DOCUMENT:	APPARATUS:	DATE:
TECHNICAL NOTE	61XX	22/01/2008

To be applied to: \checkmark MyLab60 \checkmark MyLab70

TECHNICAL NOTE N° 109

1.1 System error message at first power up

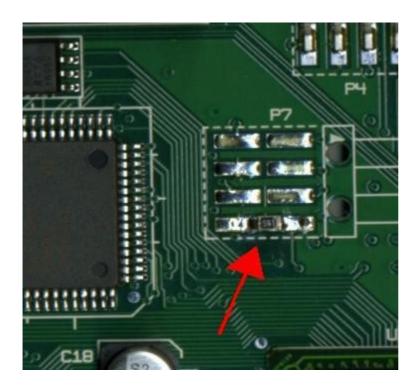
The following modification on the PVA board (code 9501110000) has been introduced in order to solve the error due to a communication problem between the i2C logic bus and the PVA board (see TN 105):

• a resistor (560 Ω , 1/8W, 1%, code 3100000372) has been inserted between pin 7 and pin 8 of P7 (not mounted)

The modifications change the IC of the part to 4. The modification is requested in case of specific problem.

1.2 System error message at first power up

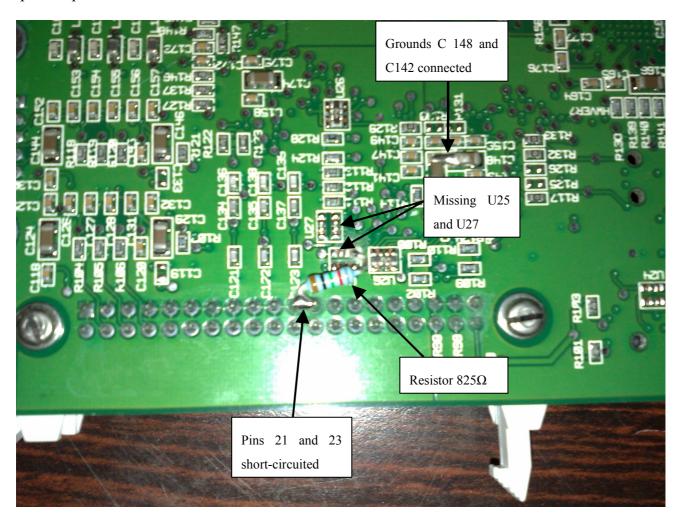
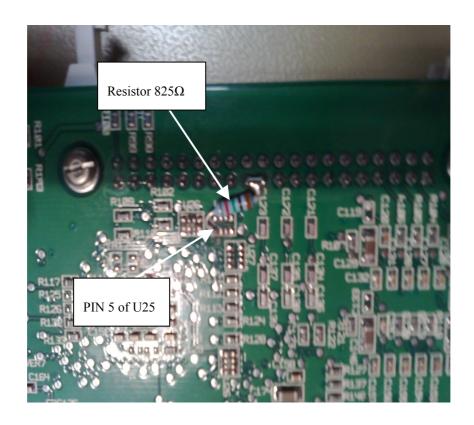
The following modification on the PVA board (code 9501110000) has been introduced in order to solve the system error message at first power up (see TN 105):

- U25 and U27 (code 5100000459) are no more mounted
- the pins 21 and 23 of connector P1 are short-circuited
- a resistor (825Ω, 62mW, 1%, code 3100000462) has been inserted between pin 5 of U25 and pin 21 of P1
- the grounds of C148 and C142 have been short-circuited

The modifications change the IC of the part to 3. The modification is requested in case of specific problem.

Details of the modifications (U25 and U27 has 8 pins).

2.0 MODIFICATION ON DIP BOARD

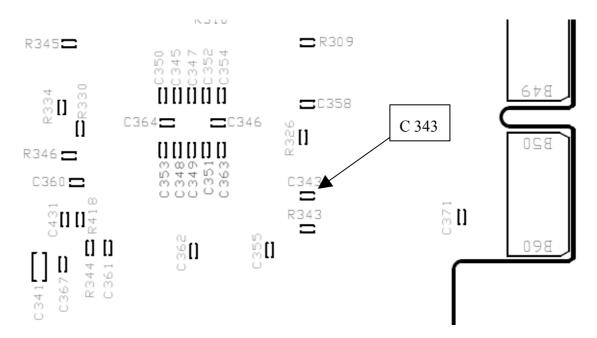
The following modification on the DIP board (code 9501093000) has been introduced in order to solve a problem on the clock line:

This will create random hanging with system error message due to the DIP board.

• a ceramic capacitor 10 pF 50 V has been inserted in position C343.

The modifications change the IC of the part to 3. The modification is requested in case of specific problem.
